**SL 2006-001**

Used On: 323 FIRE ATTACK SYSTEM

## Installation of 323 Lower Shroud Brackets

No: Service Letter 323 Shroud Bracket Modification - HeliAir

#### Installation instructions for the bottom shroud brackets Simplex p/n 323-303007-001

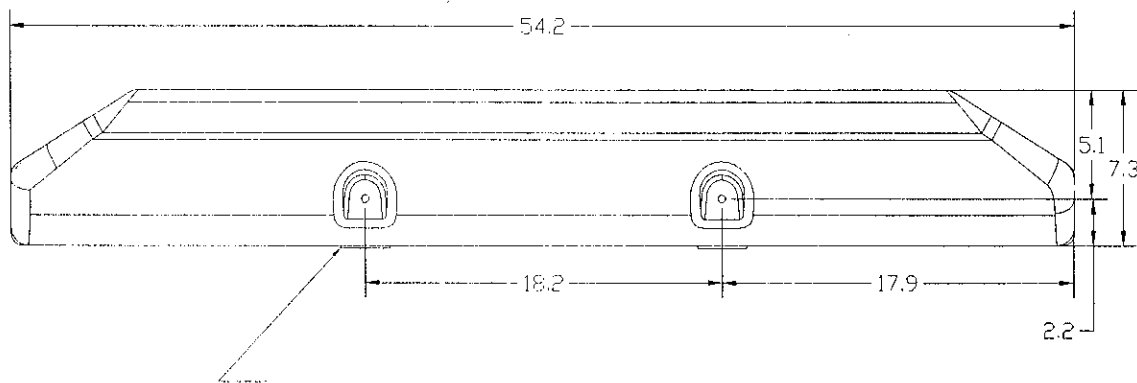
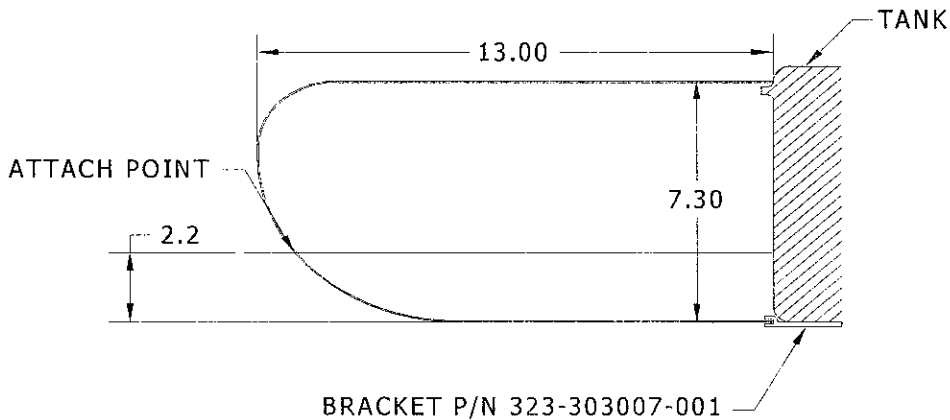
**DESCRIPTION:** The front shroud p/n 323-303 002-002 of the 323 Fire Attack System is rotating downward from unanticipated loads. This letter addresses the problem by the addition of two brackets p/n 323-303 007-001 to capture the bottom edge of the shroud and prohibit any rotation.

1. Loosen the two 3/8<sup>th</sup> inch elastic self locking nuts at front of shrouds several turns to allow a limited amount of travel.
2. Locate the brackets as shown. The brackets should be fully seated over the rubber trim and the shroud square with the tank.
3. Back drill the fiberglass tank using the brackets as drilling fixtures with a number 10 ( 4.8mm) drill bit.
4. Apply a small amount of silicon sealant between the bracket and the tank and bolt the brackets to the tank using the hardware provided. The larger 1 inch fender washer is to be located on the inside of the tank.
5. Retighten the two 3/8<sup>th</sup> inch elastic self locking nuts to secure the shroud firmly to the tank.
